R610 St. Patricks Junction Upgrade Scheme

Stage 1 Road Safety Audit

Document reference: 100287864-MMD-REP-RSA-2026-030 | B

Figure 2.2: Proposed junction layout

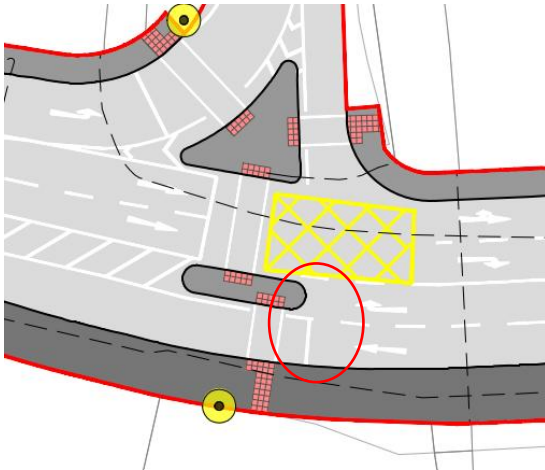
Summary: Right turning vehicles may believe they are uncontrolled and turn at the same time as eastbound traffic potentially leading to turning related collisions.

A stop line has been provided for westbound traffic on Rochestown Road, however right turning traffic is to pass in front of the traffic island. The provision of a controlled pedestrian crossing on the N28 on-slip indicates that the Rochestown Road right turn lane will be required to be signal controlled. However, the presence of the traffic island, potential positioning of traffic signals and lack of a stop line may mislead right turning motorists into believing they are not controlled. Vehicles turning right uncontrolled against eastbound traffic could result in vehicles turning across the path of ahead traffic increasing the risk of collisions. In addition, vehicles may fail to stop for the pedestrian crossing leading to an increased risk of collisions with crossing pedestrians.

Modify the signal-controlled crossing arrangement and associated traffic signal equipment and Stop lines so that the highway arrangement and signal control is clear to all users.

Problem 1.05	Yes	Yes		
Problem 1.06	Yes	Yes

Figure 2.3: Proposed markings within the junction.

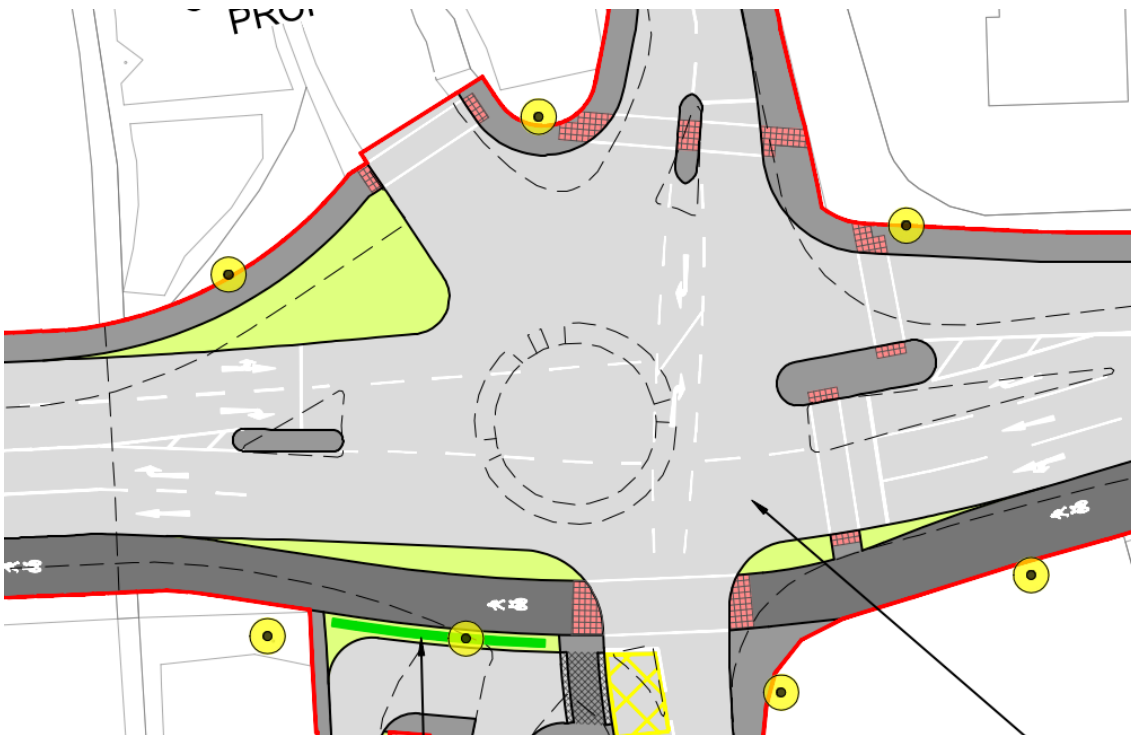
Summary: A lack of clear markings for right turn manoeuvres increases the risk of turning related collisions at the junction.

A number of issues have been identified with the markings within the Rochestown Road, N28 off-slip, Woodbrook and Mount Ovel Junction which could lead to turning related collisions.

- Right turn lanes have been marked out for drivers turning from Woodbrook and Mount Ovel, however these are minor arms with low traffic flows. The markings also extend through the Rochestown Road westbound carriageway and therefore the junction layout may not be clear for other motorists using this junction.
- The right turn lane from Woodbrook guides right turning motorists towards the stop line for eastbound traffic on Rochestown Road.
- No right turn arrow(s) has been shown within the wide right turn lane for Rochestown Road traffic and with the other markings it may not be clear where traffic, particularly from the east, is to wait and turn.

Modify the right turn lanes so that the highway layout is clearly understandable to road users.

Problem 1.07	Yes	Yes		
Problem 1.08	Yes	Yes		
Problem 1.09	Yes	Yes	A southbound cycle crossing has been incorporated to the east of the junction to facilitate westbound cyclist movements from Brookfield. In addition, the northern footpath has been upgraded to a shared pedestrian and cyclist facility to accommodate this connection.	The Audit Team accept the Design Teams response.
Problem 1.10	Yes	No	The start of the kerb line is proposed to be set back from the cycle crossing to provide sufficient space for cyclists to safely manoeuvre through the junction.	The Audit Team accept the kerb line has been set back.
Problem 1.11	No	No	Based on the predicted future cycle flows, the proposed waiting areas and storage lengths are considered adequate to accommodate the anticipated number of cyclists without creating operational or safety concerns.	The Audit Team accept the Design Teams response.
Problem 1.12	Yes	No	Signal control will be provided in the next design stage for vehicles exiting the northern arm of Clarke's Hill.	The Audit Team accept that this issue will be considered in the next design stage.

Figure 2.4: Proposed pedestrian crossing layout.

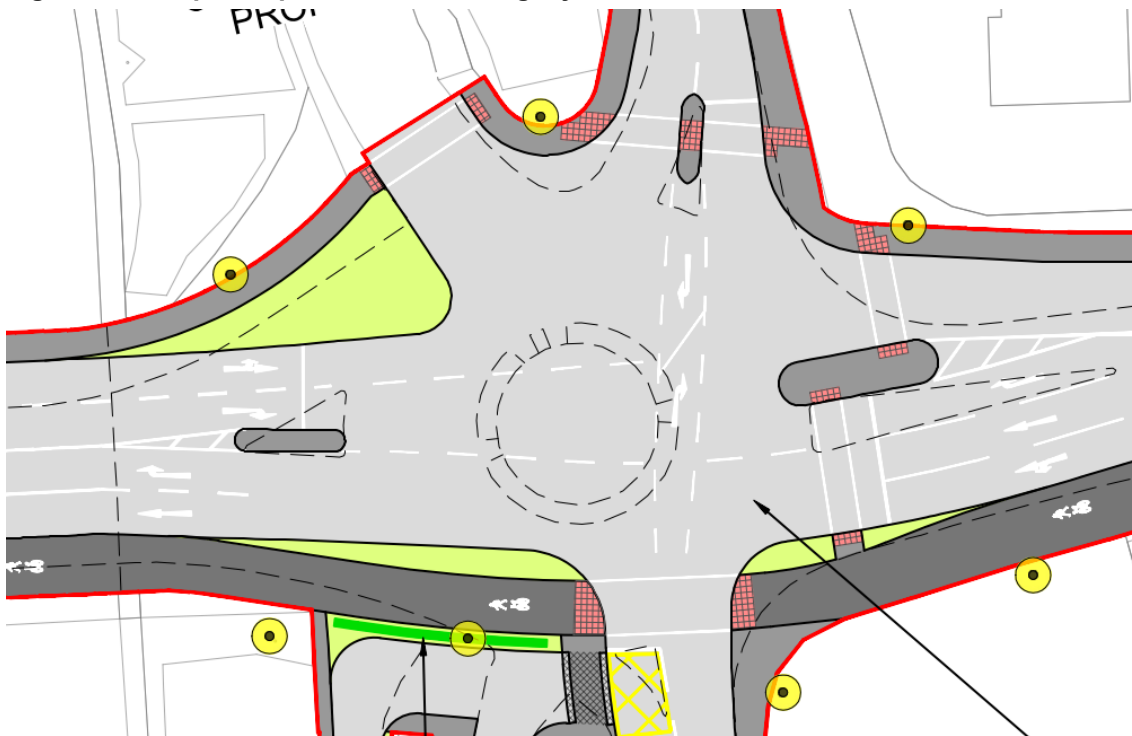
Summary: Incorrect tactile paving may mis-lead sight impaired pedestrians increasing their vulnerability to being struck.

Controlled crossings are proposed over Westbrook, Rochestown Road and Mount Ovel. The tactile paving however is shown in multiple places without the stem which indicates to blind and sight impaired pedestrians that it is a controlled crossing. The lack of a stem may mislead users who may believe it to be an uncontrolled crossing, increasing their vulnerability to being struck by passing motorists.

Provide the correct tactile paving in line with relevant guidelines to reflect they are controlled crossings.

Figure 2.5: Proposed layout at Brookfield.

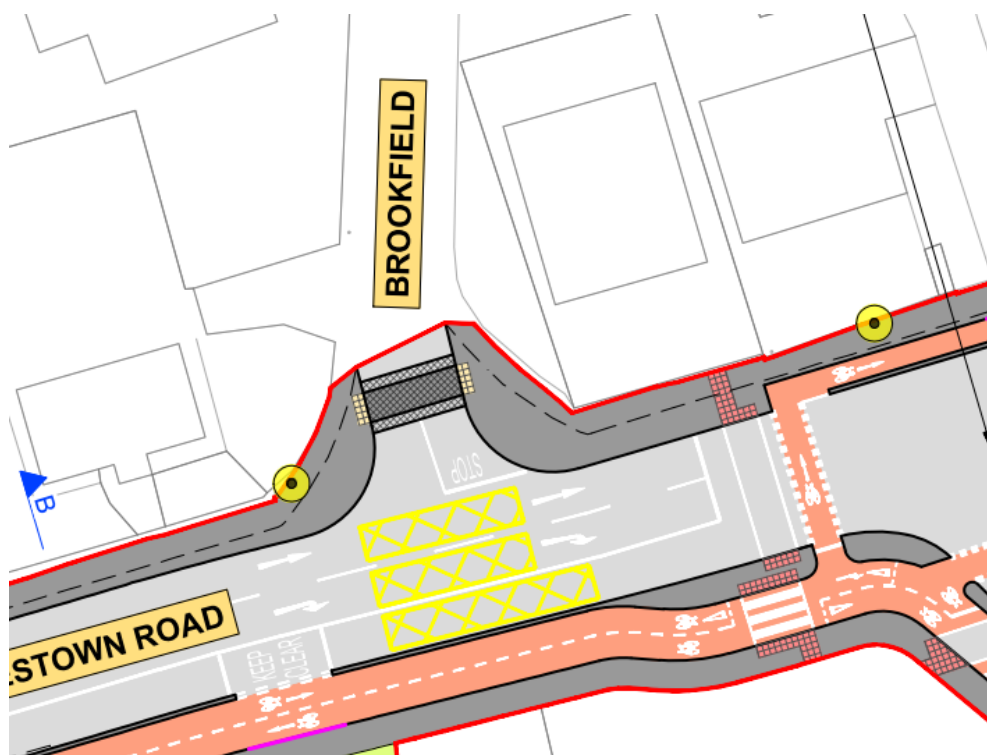
Summary: Lack of cycle provision for cyclists on the northern side of Rochestown Road to access the cycle track may lead to use of the pedestrian or unidirectional cycle crossing potentially resulting in conflict.

Should cyclists from Brookfield on the northern side of Rochestown Road wish to join the segregated cycle track on the southern side of Rochestown Road, they will be required to cross three lanes of traffic and be vulnerable to colliding with motorists. Alternatively, they may use the signalised pedestrian or unidirectional cycle crossing at Clarkes Hill and be at risk of colliding with pedestrians or cyclists.

Provide appropriate links between the northern and southern sides of Rochestown Road, this may involve providing a bi-directional cycle track across Rochestown Road.

Figure 2.6: Proposed cycle track layout at Clarkes Hill.

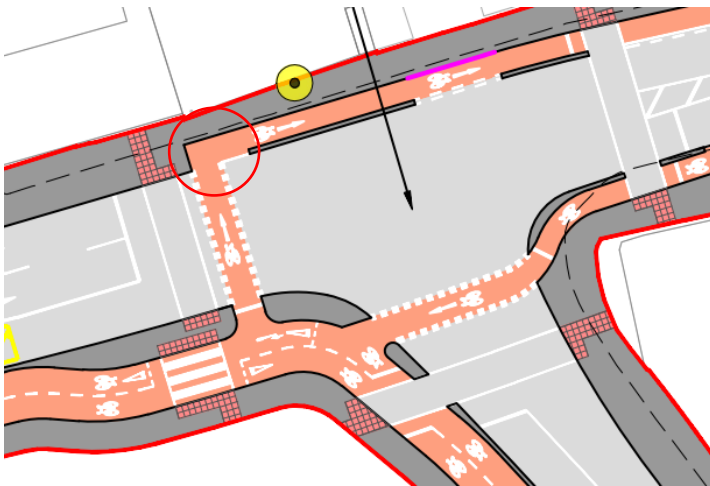
Summary: Sharp turn for cyclists may result in the kerb being clipped or over ridden leading to falls from bikes.

Cyclists from the southern side of Rochestown Road crossing to the northern side and heading east are expected to make a 90-degree turn. This sharp turn could be a difficult manoeuvre for some bikes to undertake which could result in the kerb being clipped or over ridden. Should bikes strike the kerb, it increases the risk of cyclists being unseated which may result in cyclists falling from their bikes leading to personal injury.

Relax the angle of the cycle track so that it is more gentle and easier for cyclists to turn.

Figure 2.7: Proposed cycle track layout at Clarkes Hill.

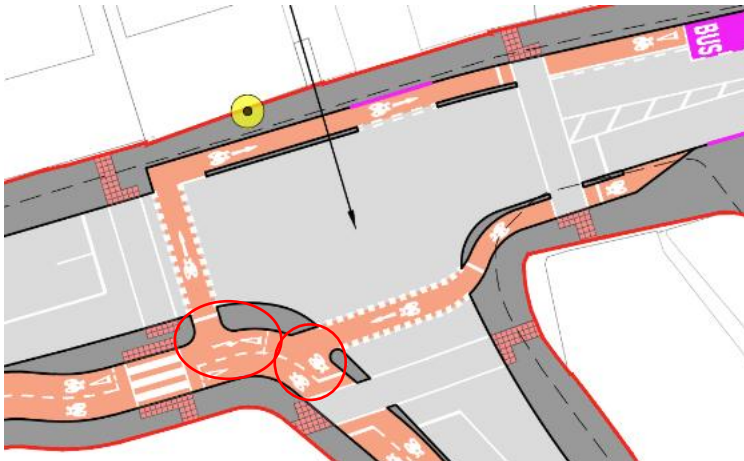
Summary: Insufficient length of cycle track may lead to conflict with other cyclists.

The layout proposes locations where cyclists are to stop or give-way to other cyclists. The Road Safety Audit Team is concerned that cyclists waiting at these Stop and Give-way lines may block the path for other cyclists continuing on a different route potentially leading to conflict between cyclists.

Provide a sufficient length of cycle track for cyclists to wait without hindering other cyclists travelling in a different direction.

Figure 2.8: Proposed arrangement at Clarkes Hill.

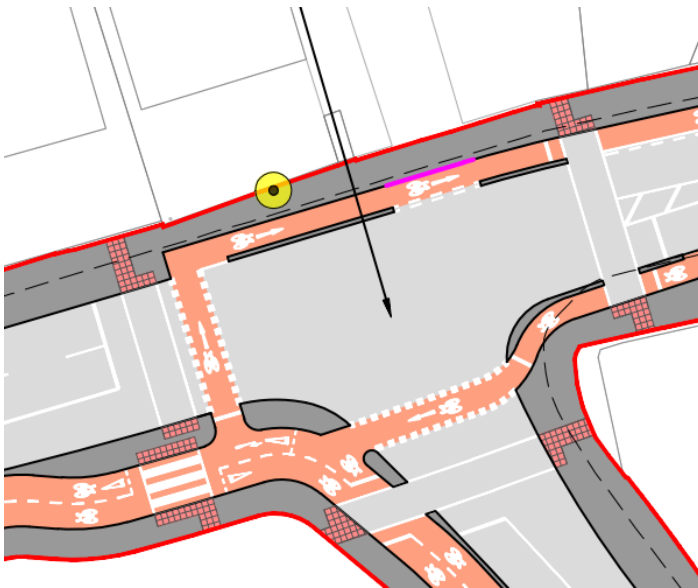
Summary: Lack of control for those properties entering / exiting within the signalised junction could result in rear end shunt and turning related collisions.

Access to several properties is proposed within the signalised junction which do not appear to be controlled. The lack of control could result in motorists exiting the properties into the path of other traffic flows that have a green traffic signal which could result in conflict. Furthermore, through traffic may not expect vehicles to be slowing to turn within the junction leading to rear end shunt related collisions.

Provide signal control for those exiting from Clarkes Hill northern arm. The junction may need formalising and potentially narrowing

Figure 2.9: Proposed Crossings at Clarkes Hill.

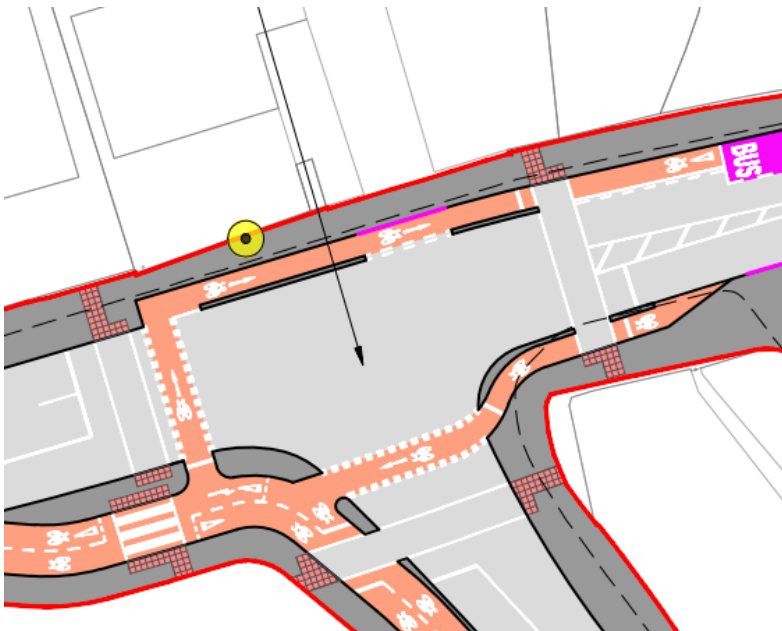
Summary: Lack of appropriate green times for length of crossing may result in pedestrian collisions with motorists and cyclists.

The crossing widths, particularly on Rochestown Road eastern arm and Clarkes Hill are wide taking into account crossing of the cycle track. Should the pedestrian green times not be sufficient in length for pedestrians to complete their crossing movement, it could result in conflict with motorists or cyclists who may commence their movement before a pedestrian has completed their crossing.

Provide sufficient pedestrian green times to allow a pedestrian to fully cross the carriageway and cycle track prior to other signal stages receiving a green light.

Problem 1.13	Yes	No	As part of the detailed design stage, traffic modelling and signal timing assessments will be undertaken to ensure adequate pedestrian green and clearance periods are provided. The signal staging will be designed to allow pedestrians sufficient time to safely complete the crossing of both the carriageway and cycle track prior to the commencement of any conflicting traffic movements.	The Audit Team accept that this issue will be considered in the next design stage.
Problem 1.14	Yes	No	Appropriate warning signage on the northbound approach from	The Audit Team accept that this issue will be

Figure 2.13: Proposed layout at Riverside junction.

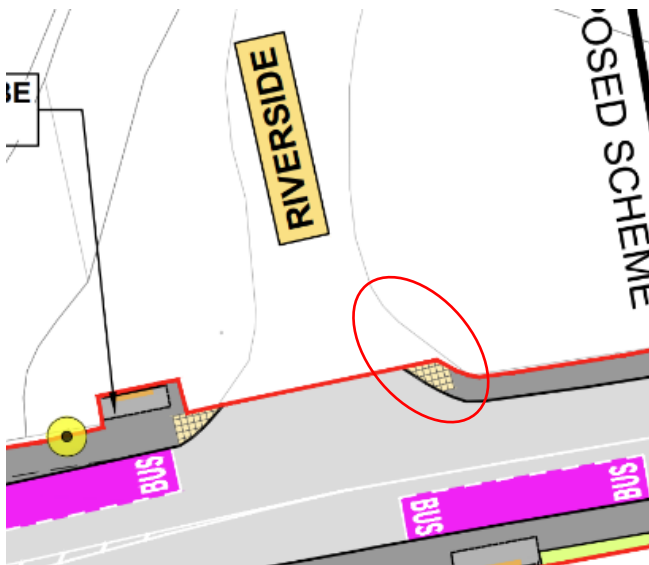
Summary: Inappropriate tie in on Riverside could result in pedestrians walking within the carriageway at risk of conflict with motor vehicles.

The kerb alignment is to be amended, however it is not clear how the kerb is being modified and connecting with the existing provision on Riverside. Should the proposed footway fail to connect with the existing footway provision it could result in pedestrians being within the carriageway at risk of conflict with motorists.

Continue the footway from Rochestown Road into Riverside.

Problem 1.17	No	No	The proposed scheme retains the existing connection to the Riverside carriageway and adjacent footpath network. As such, continuity of access for all users will be maintained	The Audit Team accept the Design Teams response.
Problem 1.18	No	No	Riverside is an access road serving approximately six residential properties, and as such, traffic volumes are expected to be low. In addition, overtaking is not a permitted manoeuvre, as indicated by the continuous centreline road marking. Consequently, the potential for	The Audit Team accept the Design Teams response.

Figure 2.14: Proposed bus stop opposite Riverside.

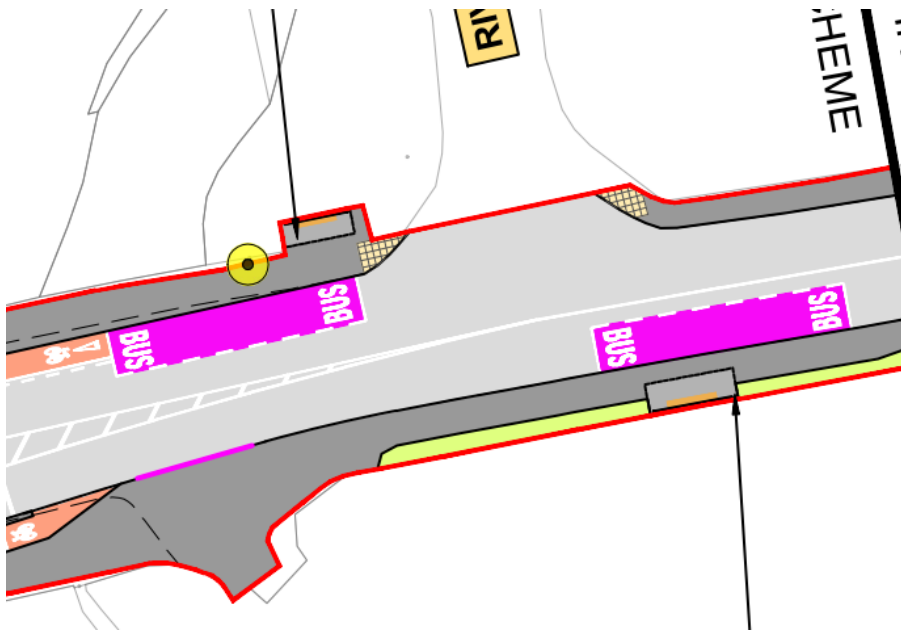
Summary: Bus stop opposite junction may lead to vehicles overtaking a bus at the same time a vehicle exits Riverside leading to turning related collisions.

The bus stop on the southern side of Rochestown Road is proposed almost opposite Riverside. There is concern that a westbound vehicle on Rochestown Road may attempt to overtake a stationary bus at the same time a vehicle pulls out of Riverside, increasing the risk of turning related collisions.

Relocate the bus stop further away from the junction.
